MODIFIED BY EI 95-030 EFFECTIVE 7/18/95	<h1>ENGINEERING INSTRUCTION</h1> <p>NEW YORK STATE DEPARTMENT OF TRANSPORTATION</p>	
SUPERSEDED BY EB 96-032 EFFECTIVE 7/19/96	SUBJECT: DISTRIBUTION OF AN ADDITIONAL DETAIL FOR BRIDGE DESIGN DATA SHEETS BDD 89-51 AND BDD 89-59B - DESIGN CRITERIA FOR BRIDGES Subject Code: 7.35-4-568	
Distribution: 30 Main Office 32 Regions 34 Special		Code: <u>E.I. 89-17</u>
APPROVED:  <u>A. M. SHIROLE, Deputy Chief Engineer (Structures)</u>		Date: <u>5/31/89</u> Supersedes:

The purpose of this E. I. is to distribute a detail titled "SPlice DETAIL AT TURN BACK IN LOWER TRANSITION GUIDE RAIL" that was inadvertently omitted from the recently issued Bridge Design Data Sheets BDD 89-51, titled "STEEL BRIDGE RAIL - TWO RAIL (FOR USE ON CURBLESS BRIDGES ONLY)" and BDD 89-59B, titled "STEEL BRIDGE RAILING - TWO RAIL (FOR USE ON BRUSH CURBS ONLY) Sheet 2 of 2".

SPlice DETAIL AT TURN BACK IN
LOWER TRANSITION GUIDE RAIL

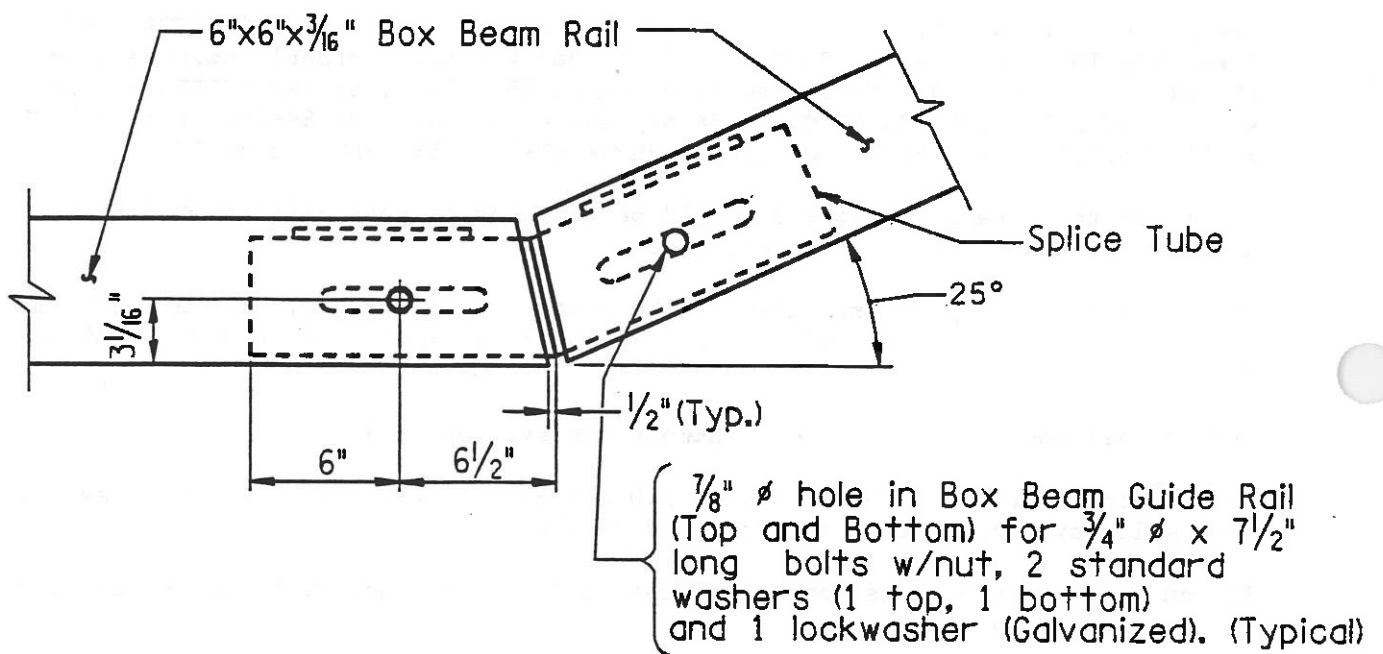
A copy of the detail (attached) should be attached to your existing BDD 89-51 and BDD 89-59B for future reference.

This detail shall be incorporated in the plans for all projects where two rail steel bridge rail is used, effective with the letting date of July 13, 1989 (June 23, 1989 PS&E).

This detail should be added by amendment whenever possible.
